Our ref: HGY/2023/0815 (C9) HGY/2023/0875 (C17) Contact: Valerie Okeiyi Date: 05/06/2024
Town and Country Act 1990 (As amended)		
Location:	45-63, Lawrence Road, London, N15 4EN	
Proposal:	Approval of details pursuant to condition 9 (CHP), and condition 17 (CHP facility and associated infrastructure) attached to planning permission HGY/2016/1213.	
Wording of condition 9	Prior to commencement of the development, details of the CHP must be submitted to evidence that the unit to be installed complies with the emissions standards as set out in the GLA SPG Sustainable Design and Construction for Band A. A CHP Information form must be submitted to and approved by the LPA. The development shall then be carried out strictly in accordance with the details approved by the Council and shall be maintained as such thereafter. Reason: To Comply with Policy 7.14 of the London Plan and the GLA SPG Sustainable Design and Construction.

Carbon Management Response 17/08/2023

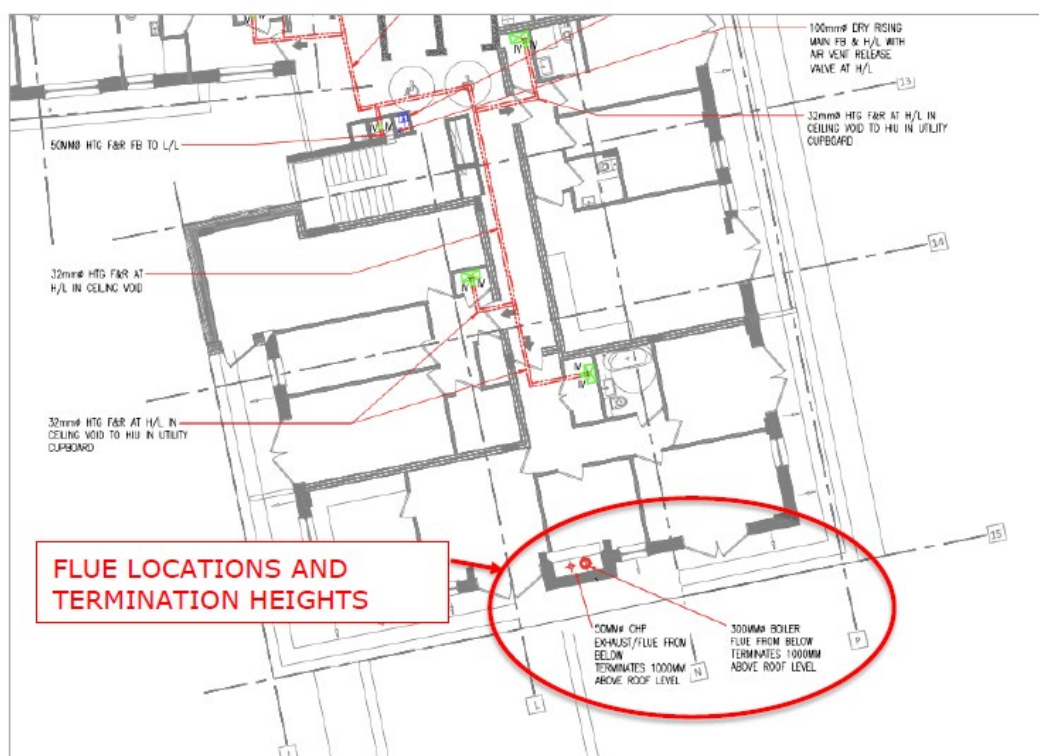
- Please provide the complete flue arrangement plan showing the location of the flue terminations and their respective termination heights.
- Please provide more information on operation and management strategy. On failure of CHP, what alternative strategy will be applied? Also, what is the decarbonisation strategy?
- Please provide a method to allow for the future connection to any neighbouring heating network (including the proposed connectivity location, punch points through structure and route of the link).
- Demonstrate how the units to be installed complies with the emission standards as set out in the London Plan SPG Sustainable Design and Construction for Band A. Also, include a CHP information form.

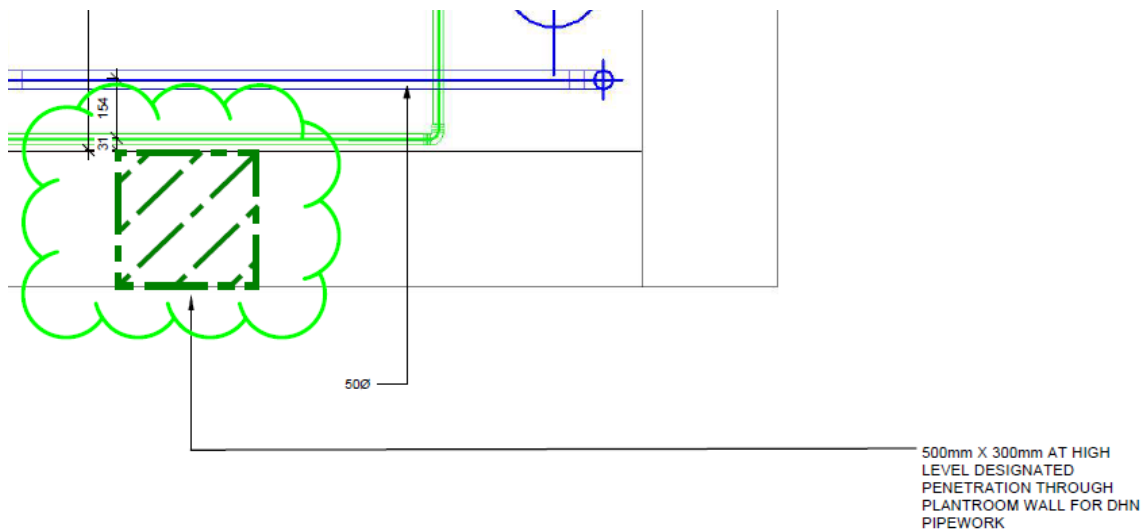
The applicant confirmed that the Flues will terminate a minimum of 1000mm above highest roof level, as shown in the drawing below:
